Contract No. T200911302.01  
Federal Aid Project No. NH-2015(22)  
US 301 & SR 1 Interchange  
New Castle County

Enclosed is Addendum No. 2 for the referenced contract consisting of the following:

US 301 & SR 1 INTERCHANGE

**ENDWALL NO. 404 - PLAN**  
SCALE: 1/2"=1'-0"

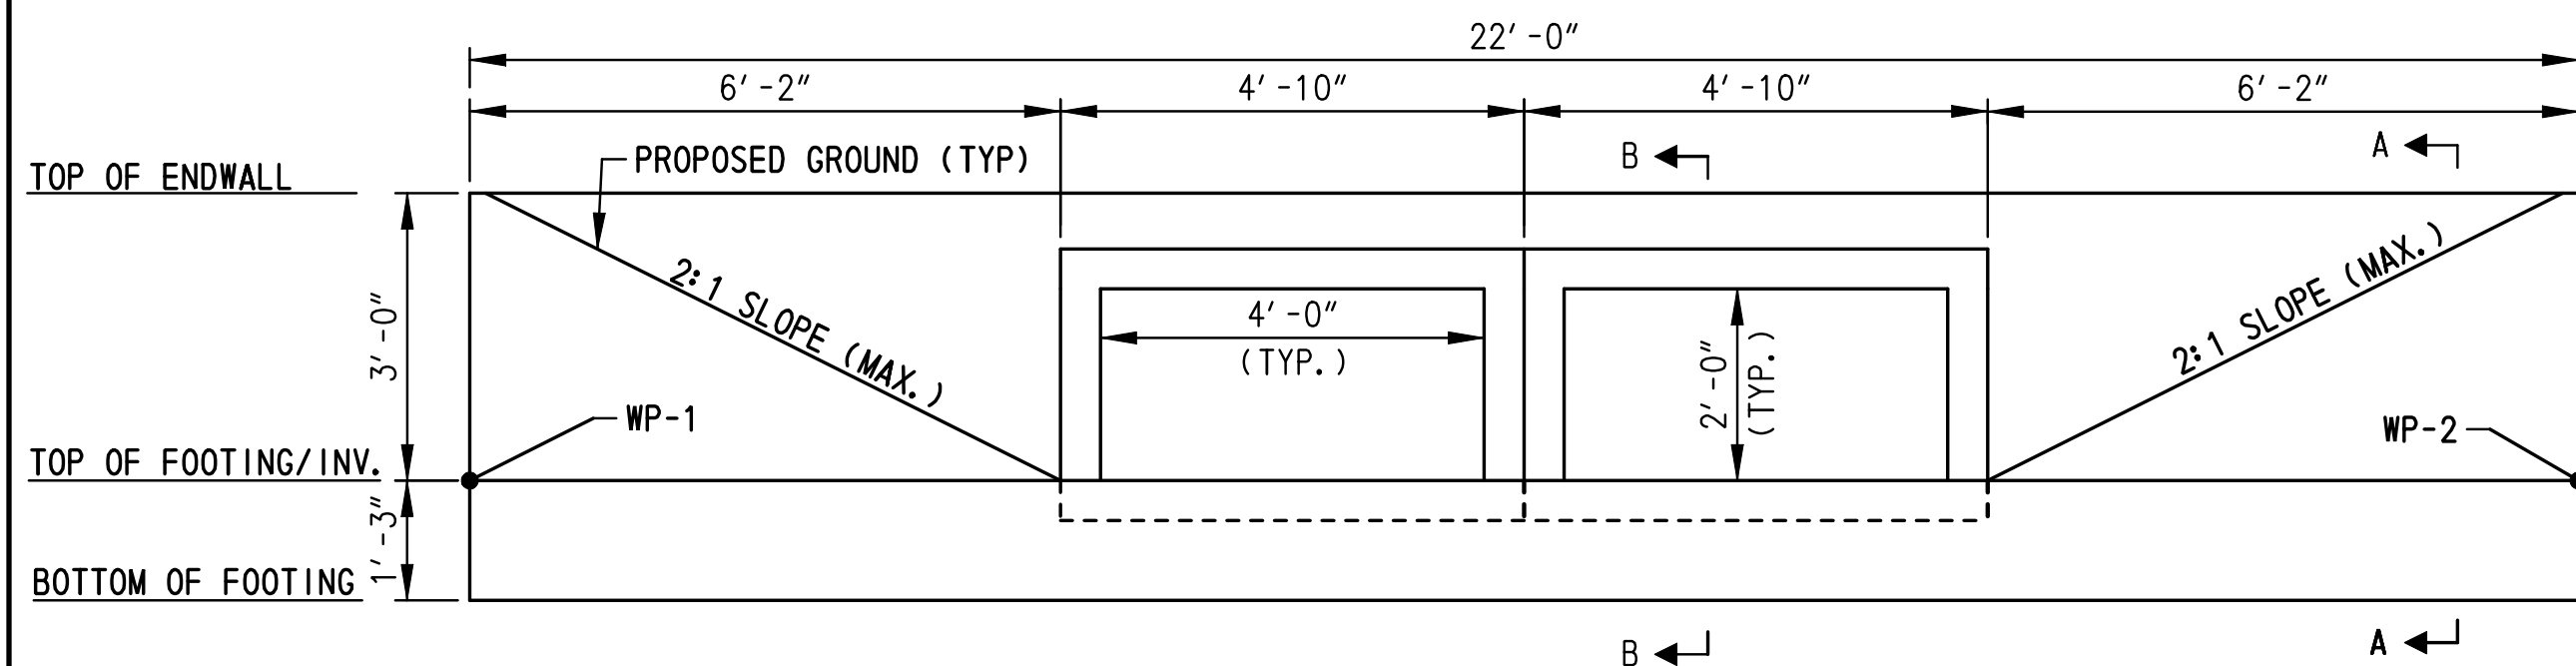
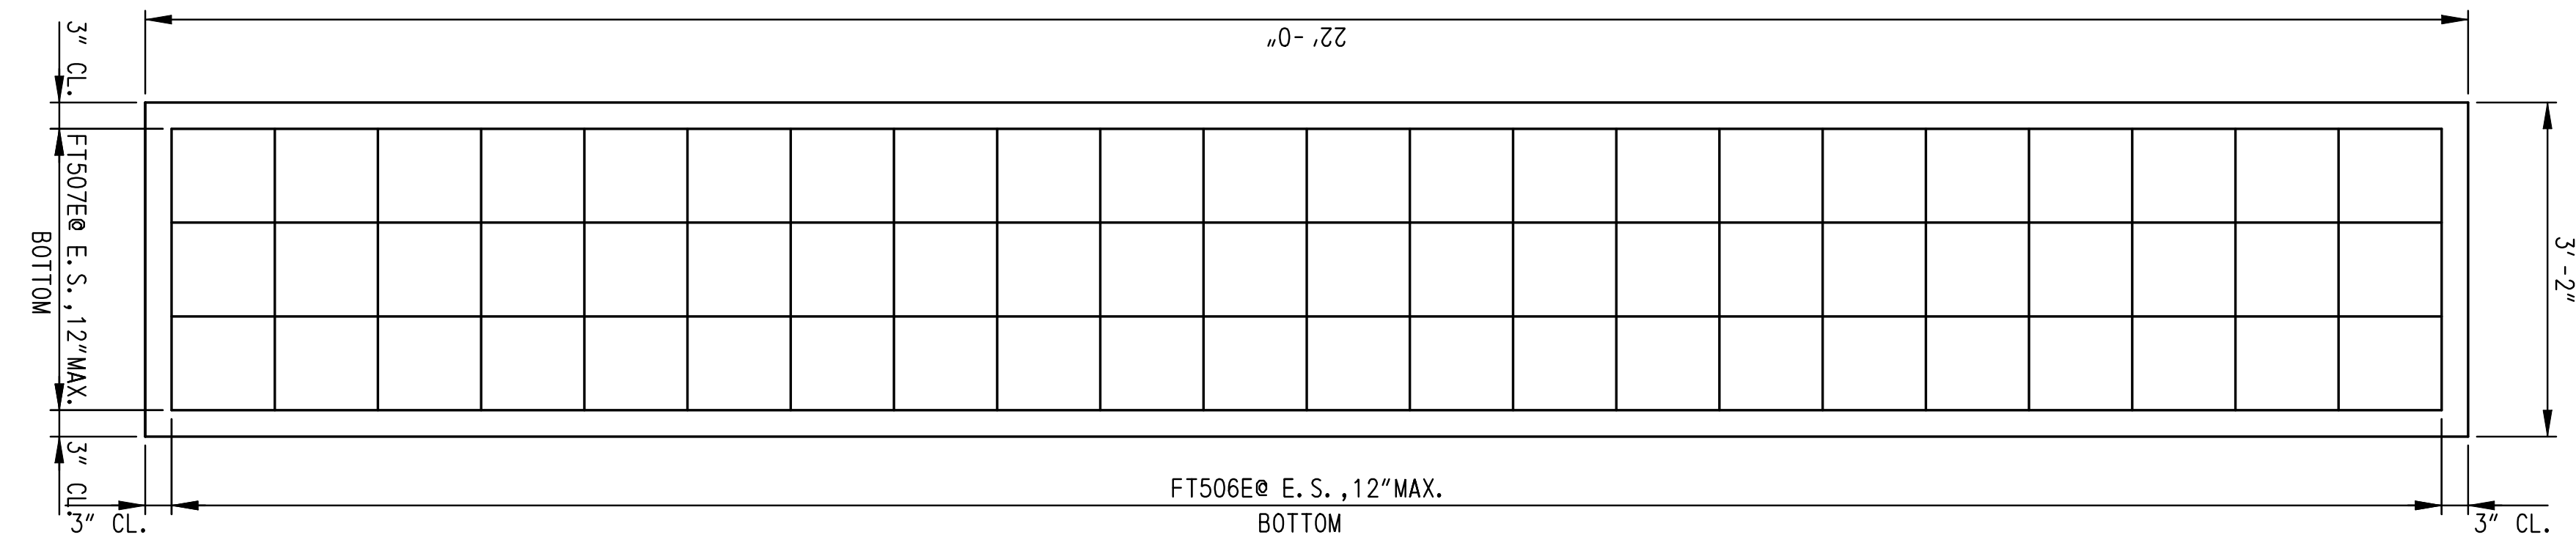
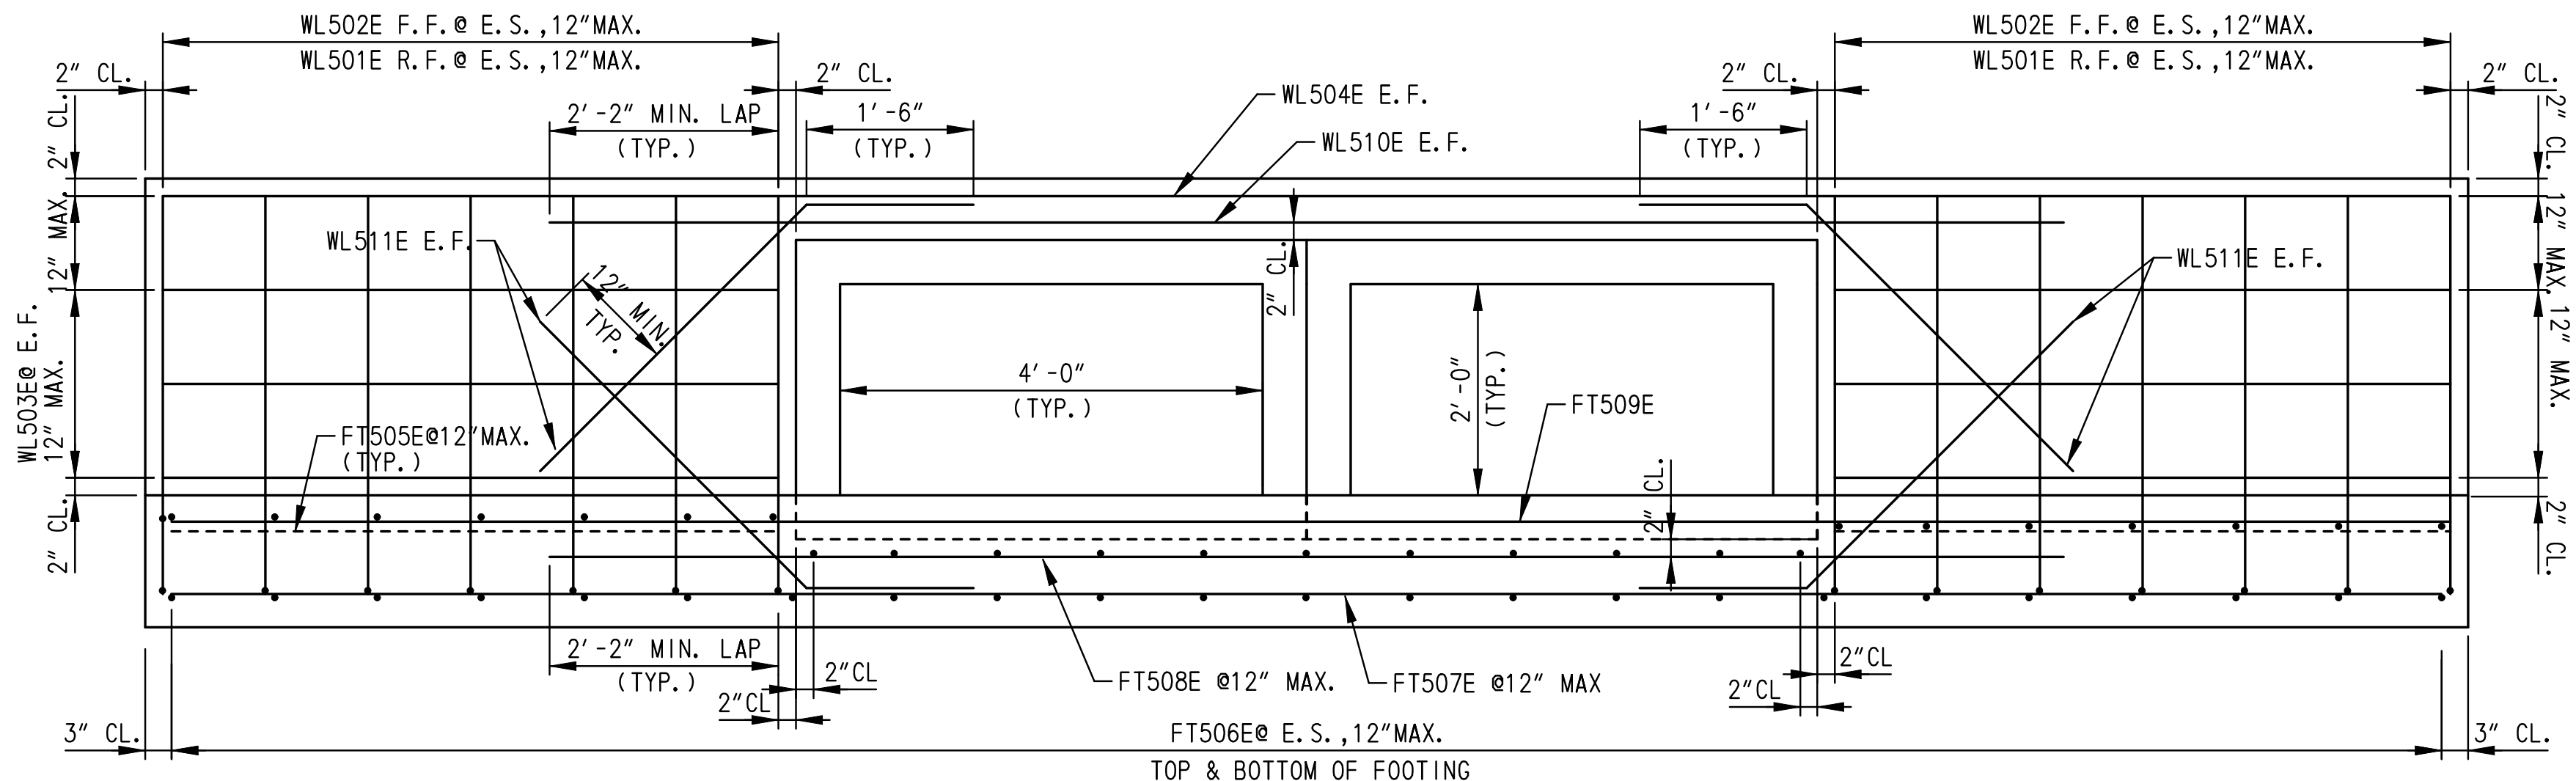
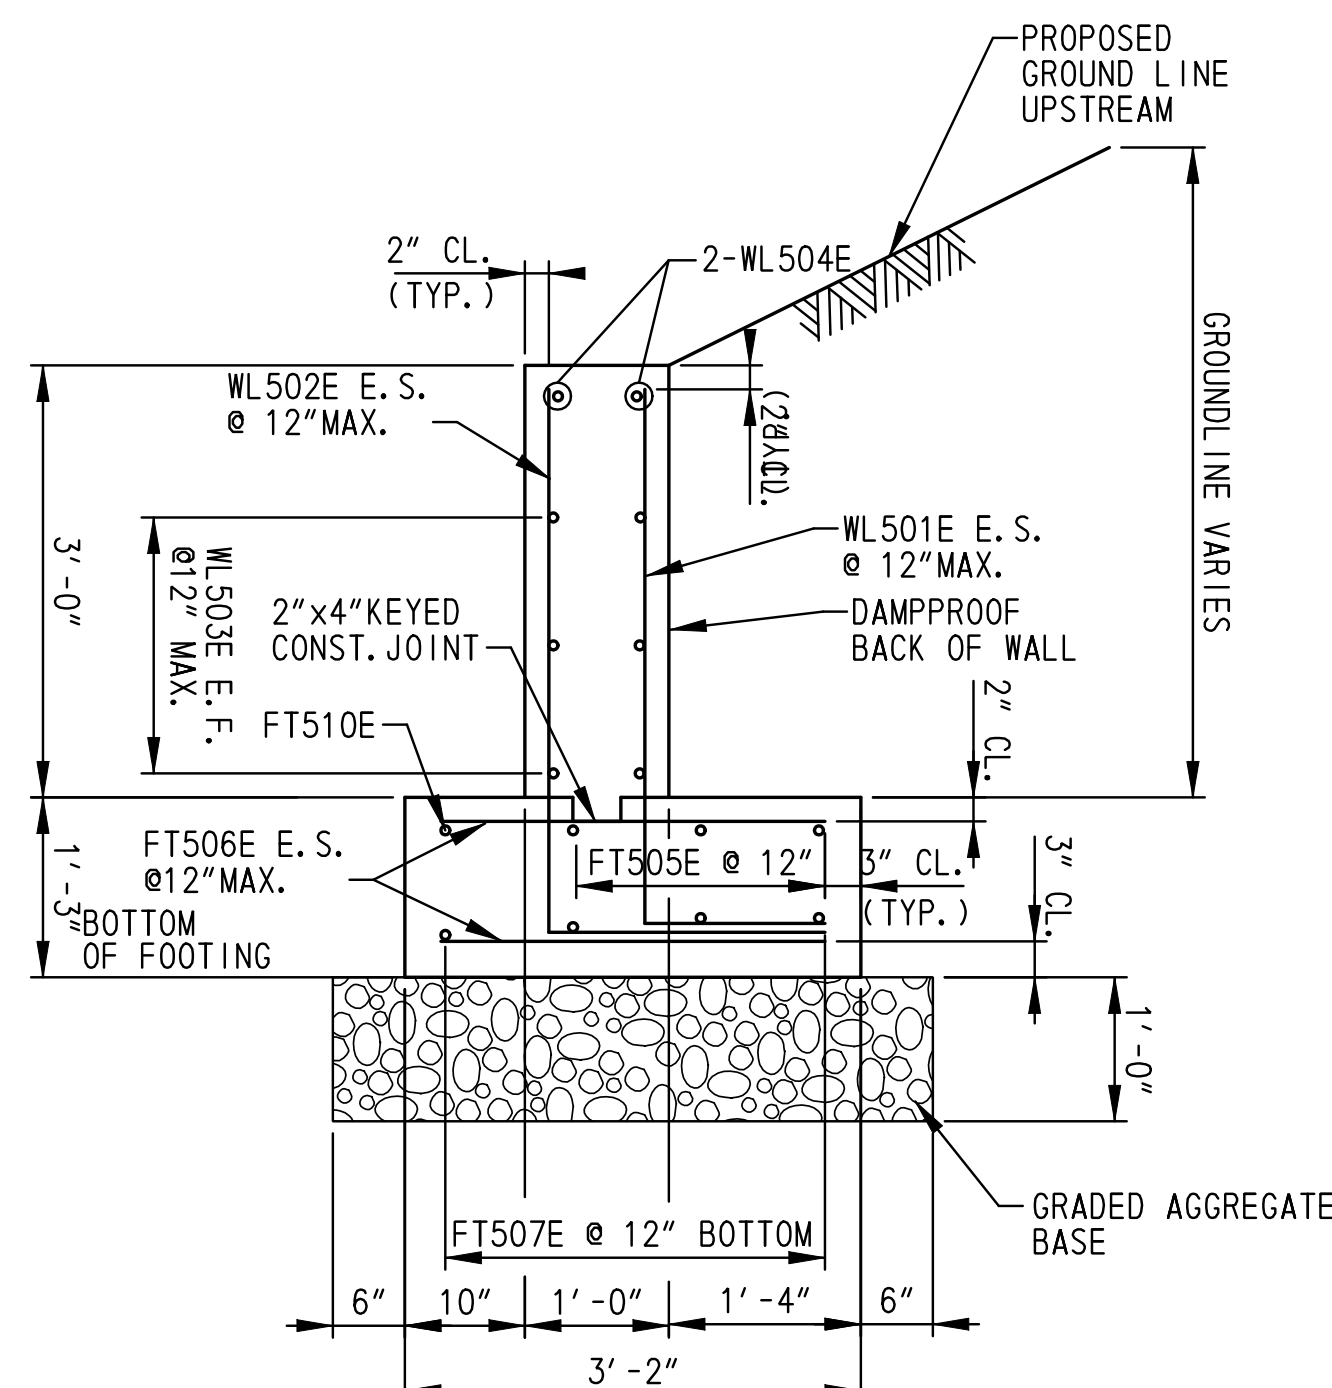
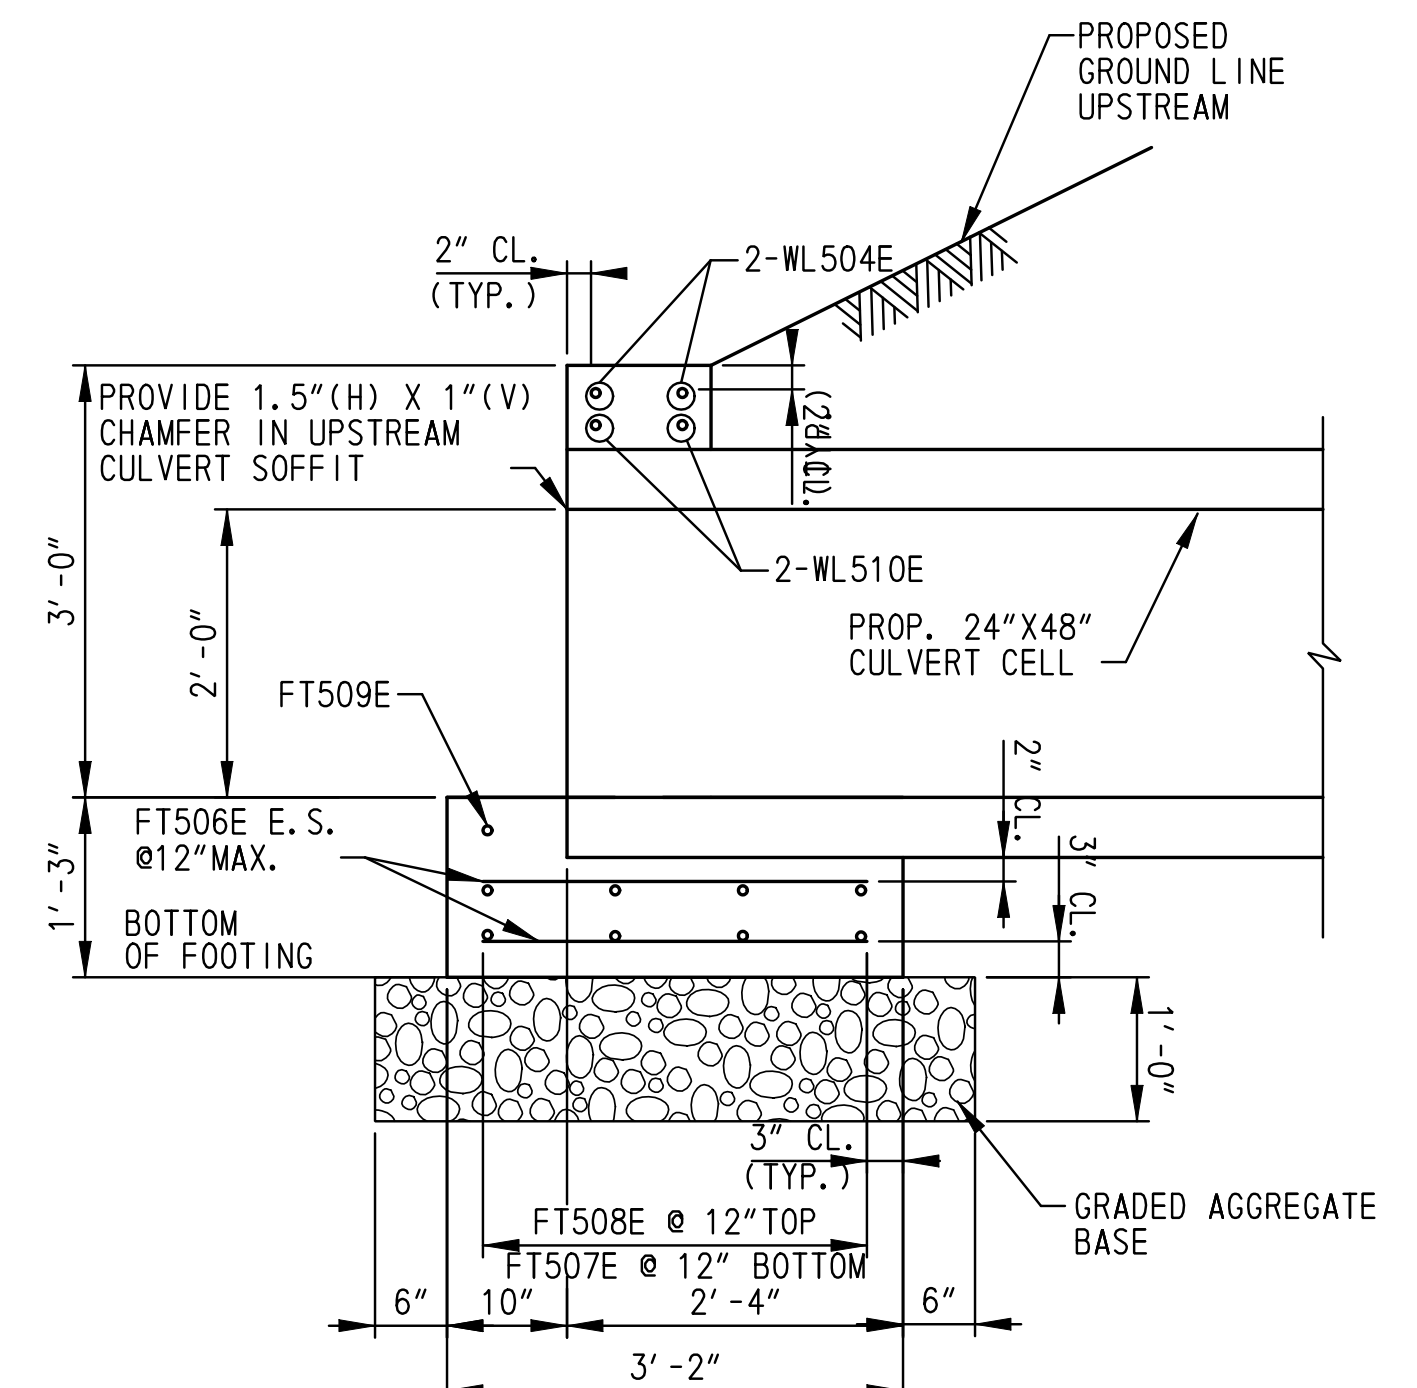
ADDENDUMS / REVISIONS	
REVIS	REVISED ENDWALL NO., MODIFIED NOTES, AND MODIFIED WORKING POINTS: BRT/DMG
